CHATHAM COUNTY PURCHASING & CONTRACTING DEPARTMENT

ADDENDUM NO. 1 TO 19-0034-4

FOR: JOHNNY MERCER BOULEVARD CORRIDOR IMPROVEMENTS

JMB CORRIDOR IMPROVEMENTS
ADDENDUM I QUESTIONS

DRAWING No.
6-01

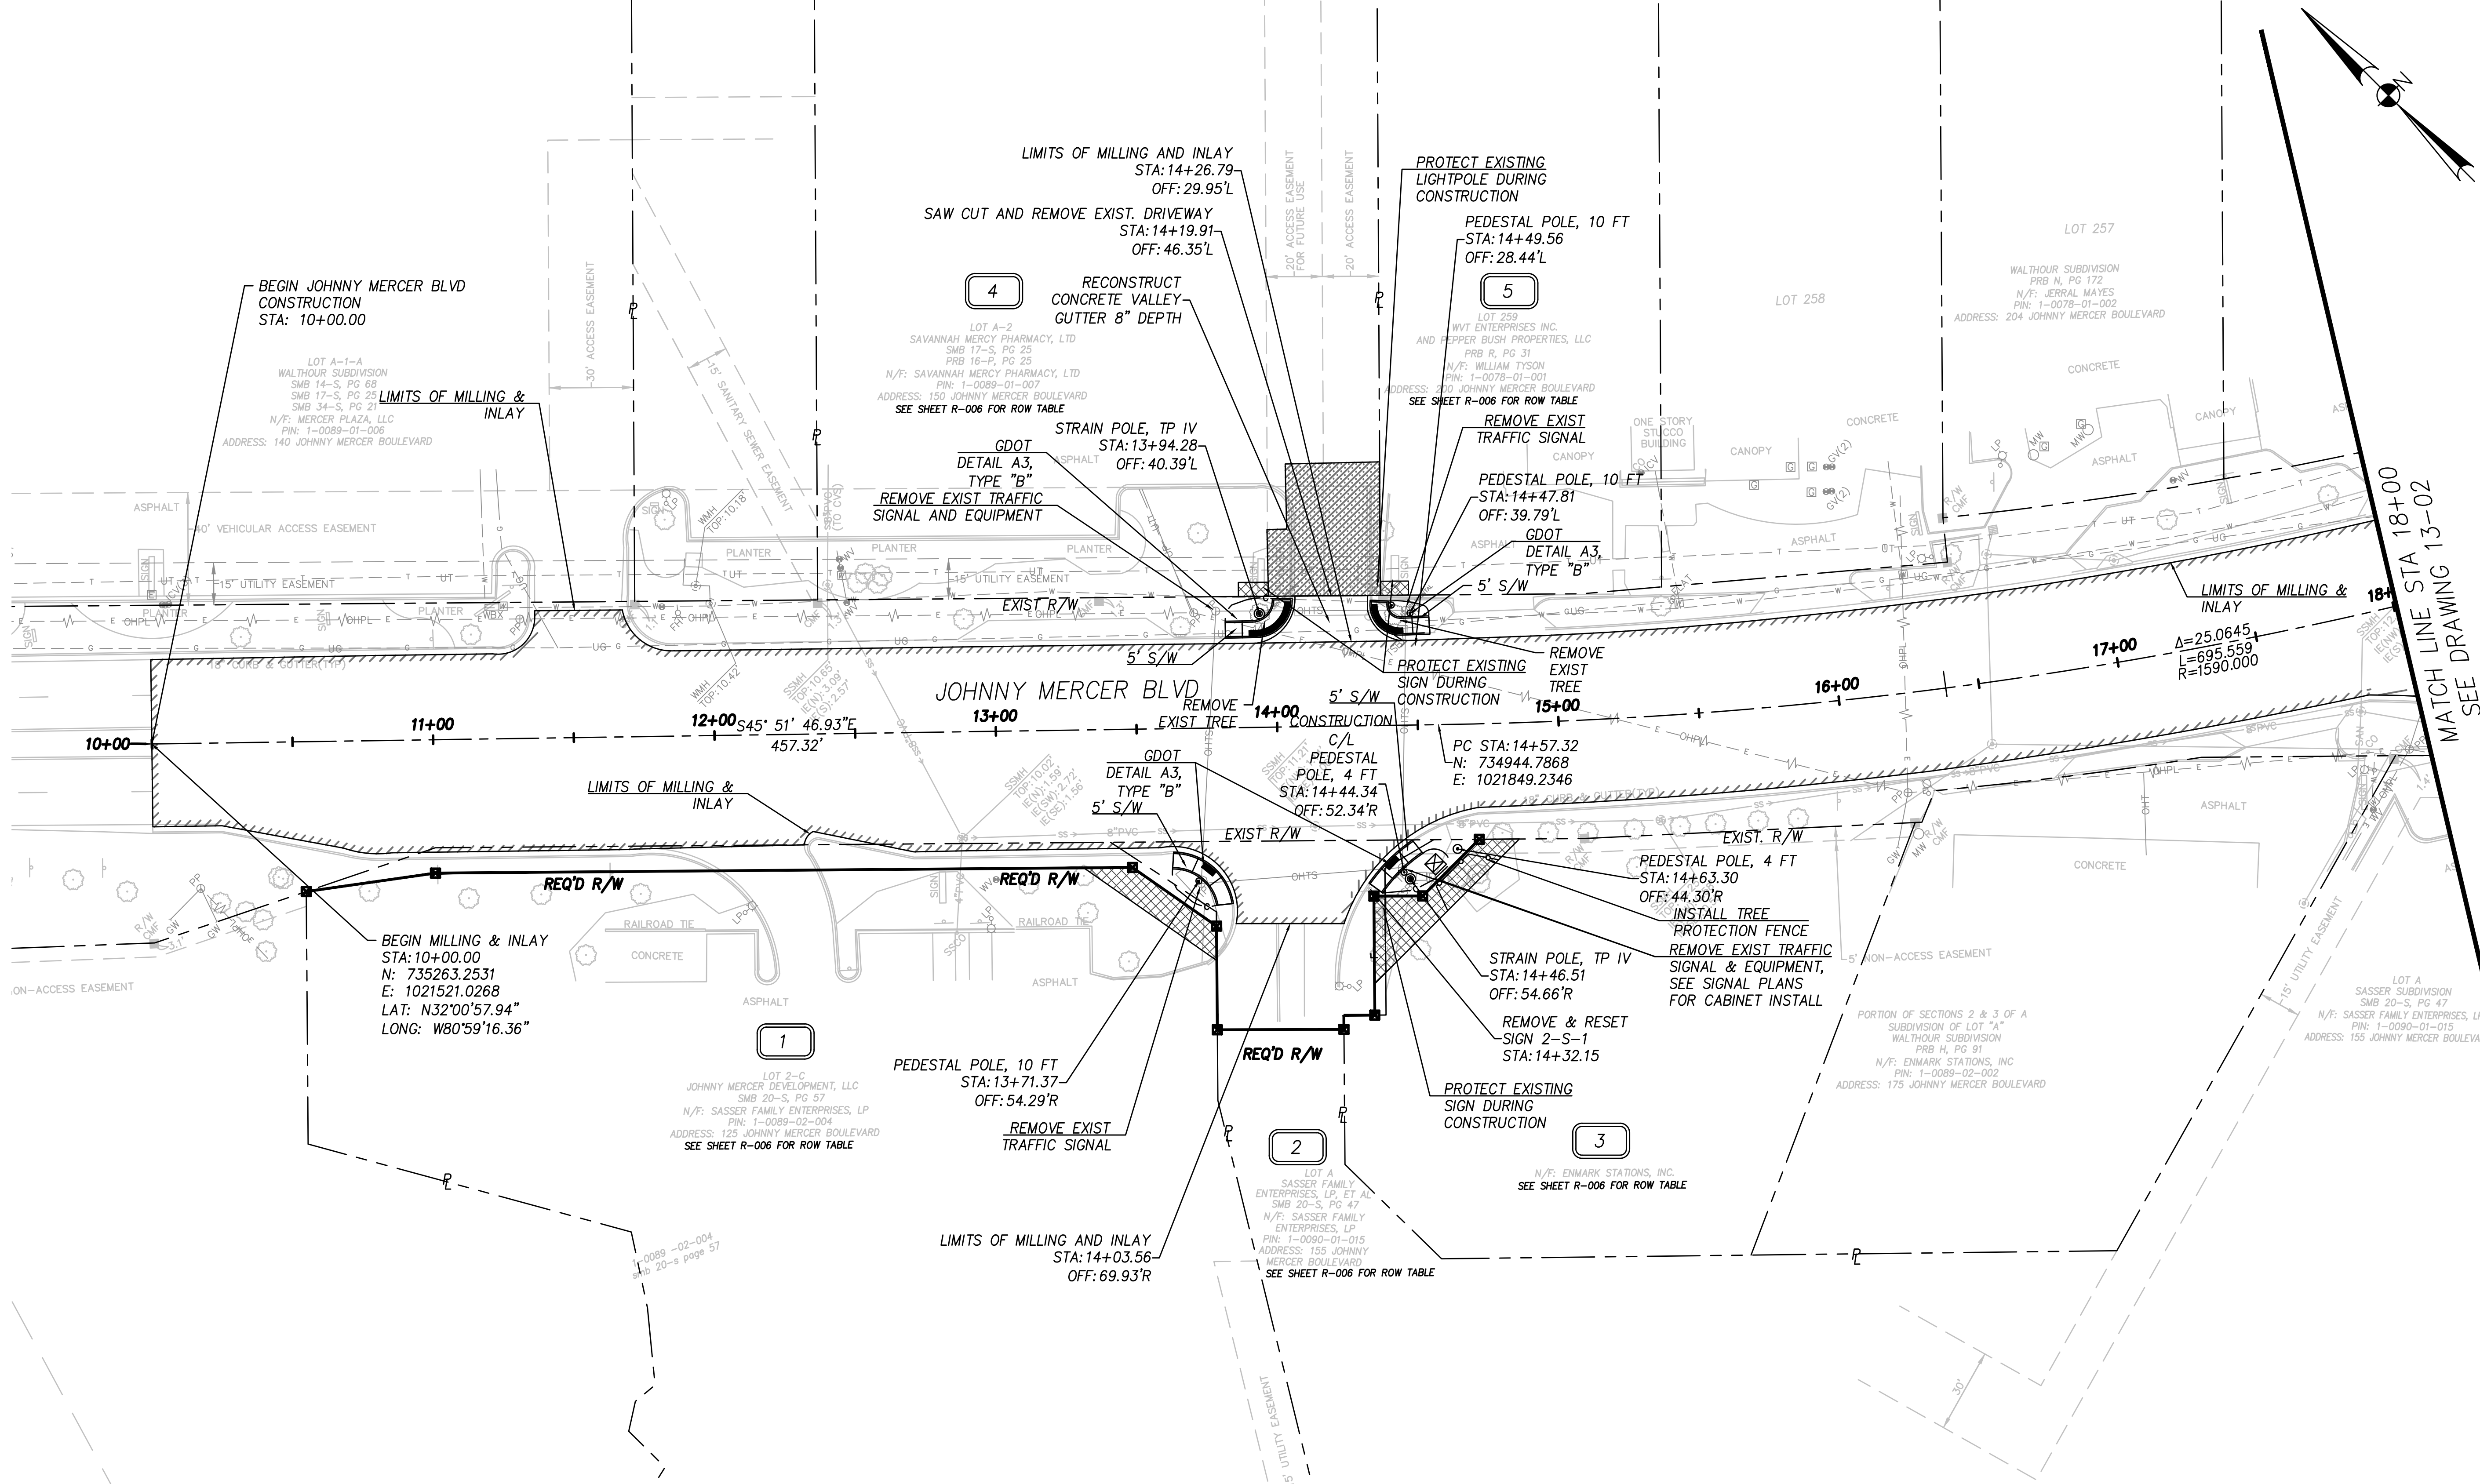
- The Class B quantity is for widening 5 feet or less. The bid sheet was revised.
7. *On milling quantity on the bid form, have a rather large discrepancy between the bid form quantities. I am coming up with more in line with the engineer's quantities on sheet 6-01. Which is correct and please clarify. Since milling quantities seem to be off it is throwing, 12.5MM, OGI and tack quantities off.*

- Milling and asphalt quantities were adjusted per the Special Conditions. The bid sheet reflects the adjusted paving limits.
8. *What is the lead time on turn around for submittals on traffic signals?*

MILLING VARIABLE DEPTH SY25601.025601.0

CLASS B CONCRETE, BASE OR PVMT WIDENING CY10.010.0

DRAWING No.
13-06

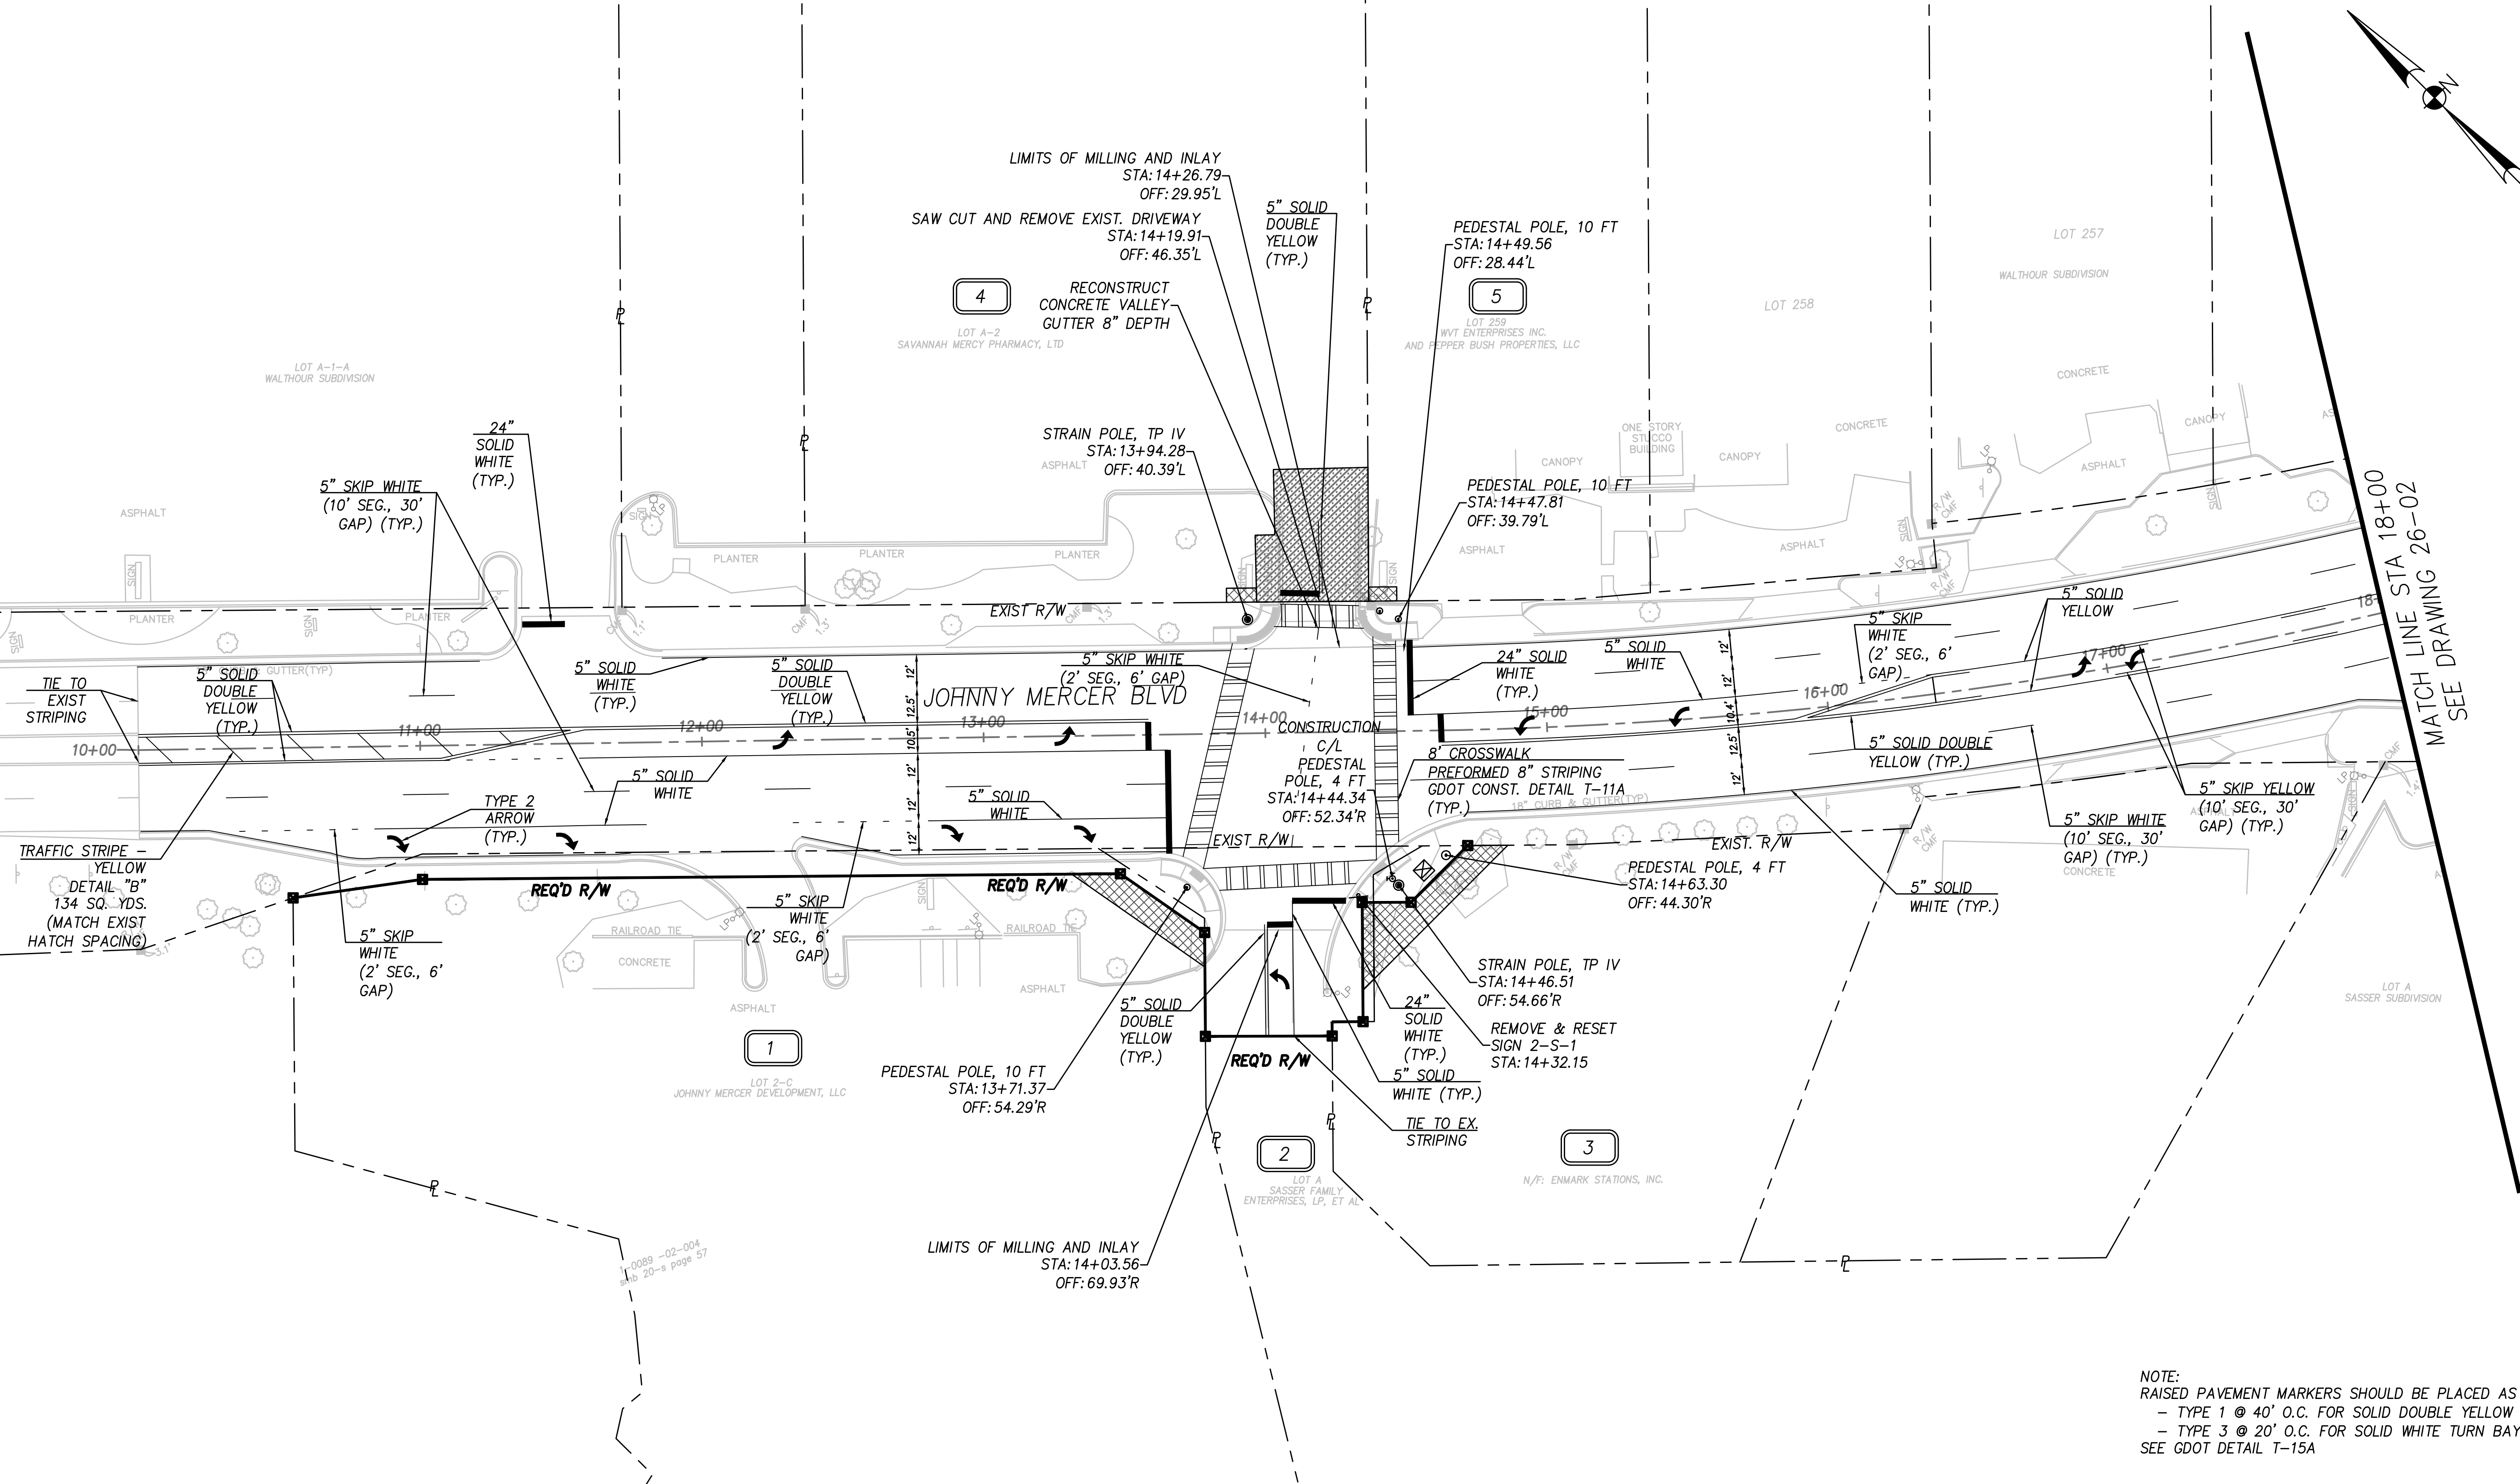
2. **CONSTRUCTION LIMITS:** Milling, paving and striping limits shown on the plans shall be extended to the Turner's Creek Bridge.
3. **COMMENCEMENT AND COMPLETION:** The Contractor shall agree to commence work under this contract within ten (10) working days after the Notice to Proceed is issued, and complete all work within 180 calendar days after the 10-day period. The Contractor shall work continuously on the project after the Notice to Proceed is issued.
